# City of Mississauga Department Comments

Date Finalized: 2023-04-05 File(s): A645.22

Property Address: 28 Cattrick St

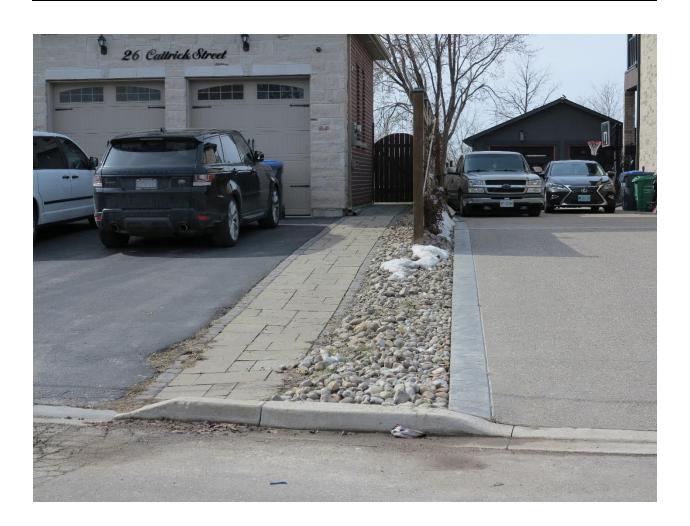
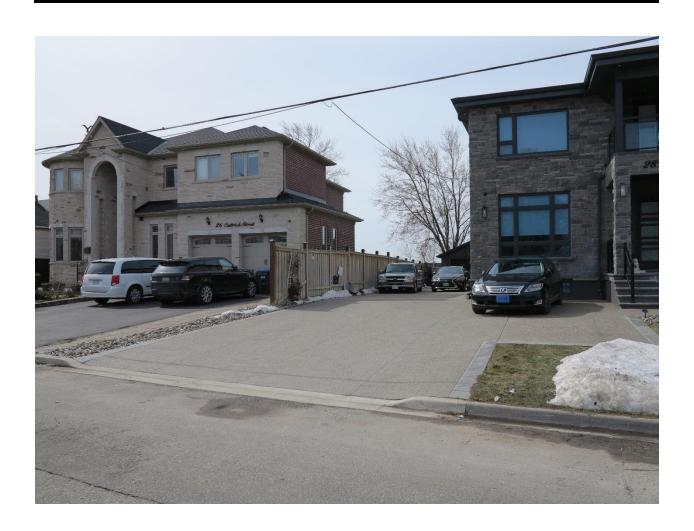
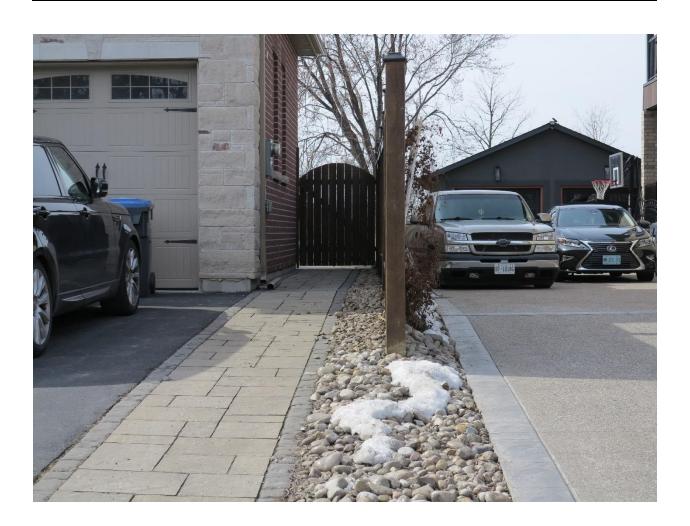
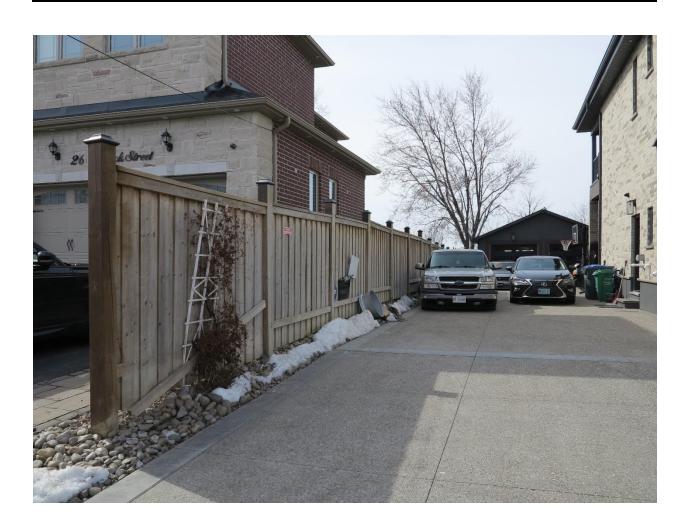
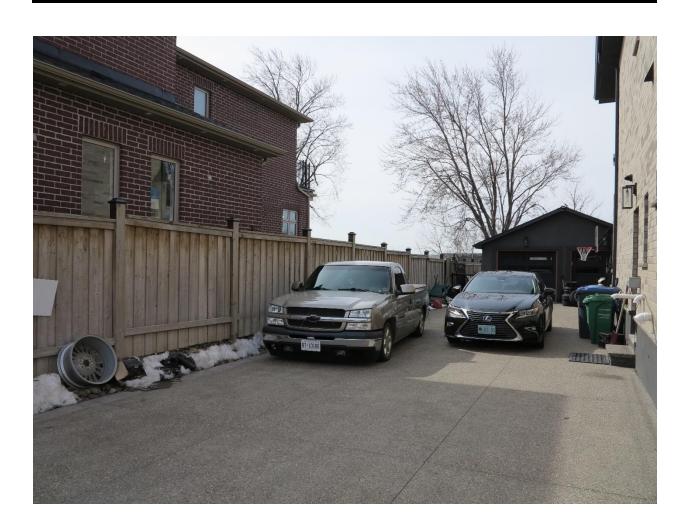
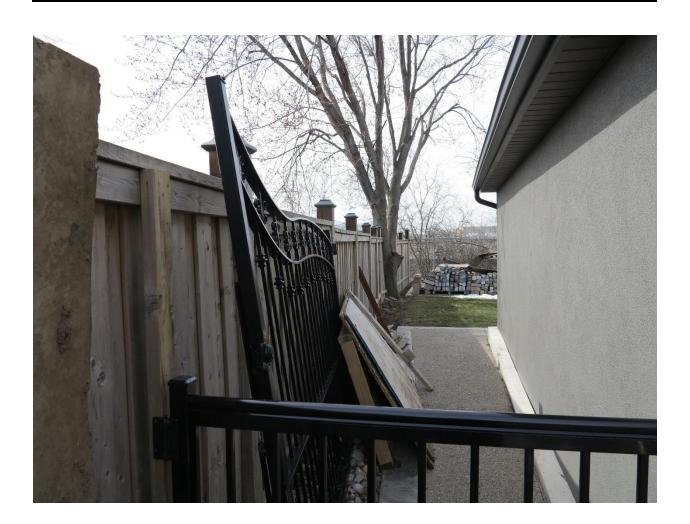
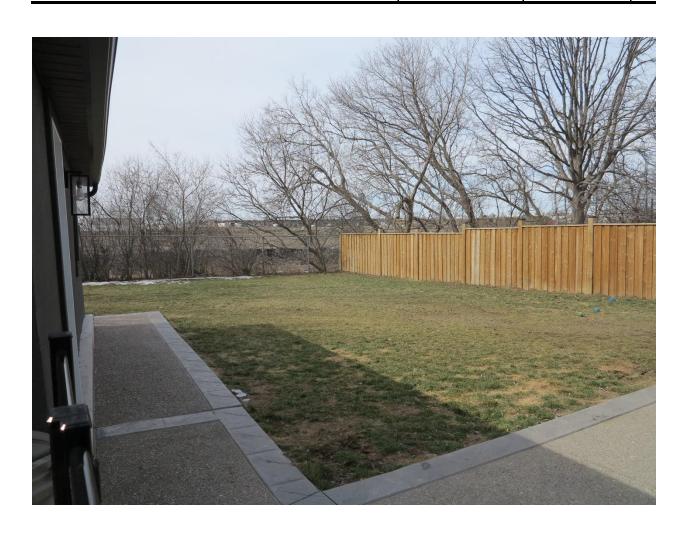
In our previous comments we indicated that with regards to the widened driveway within the municipal boulevard (the area between the municipal curb and property line) we would request that this area be reinstated with topsoil and sod should the application be modified to reflect a smaller driveway width within the subject property or if the application is not supported by the Committee, this comment is still applicable.

The variance before us is related to a driveway and walkway width. When the Transportation and Works Department reviews a variance request, frequently a site inspection is done. Acknowledging that at our initial site inspection done for the January 19, 2023 hearing date there was a considerable amount of snow cover, this department still observed no evident drainage related concerns with the request. Our initial observations were that there was a significant slope from the driveway area to the roadway where drainage could easily be directed towards the roadway and not be obstructed. The smaller area, approximately in the middle of the dwelling would be directed towards the rear yard. A good indicator of property slopes is to observe the top of the fence elevation to determine high and low points, it is evident from some of the photos submitted that from the area approximately in the middle of the dwelling that the land also slopes to the rear.

The property owner of 24 Cattrick Street has indicated localized flooding and water absorption issues, elevated water table levels, increased moisture, flooding in their basement and concerns with pumping water onto the streets which creates an unsafe and dangerous situation and ice build-up. Some of these matters may not be directly related to the subject application and any concerns related to street maintenance should be brought to the attention of the 311 call centre or the Transportation and Works Operations and Maintenance Division (North District/Malton Yard) to assess the concern.

In order to provide updated comments and have specific regard for the concerns raised by the neighbour, we re-visited the property on March 24<sup>th</sup> and are submitting a number of updated photos. From the photos it is clearly evident that there is a significant slope on the driveway which would direct any drainage onto the roadway and not the abutting property to the south, for the simple reason that the slope is towards the roadway and not the abutting property. In addition, the photos also show that the abutting property is at a higher elevation, this is evident when looking at the photos and looking at the bottom of the fence, and this would halt the drainage being directed towards the abutting property.
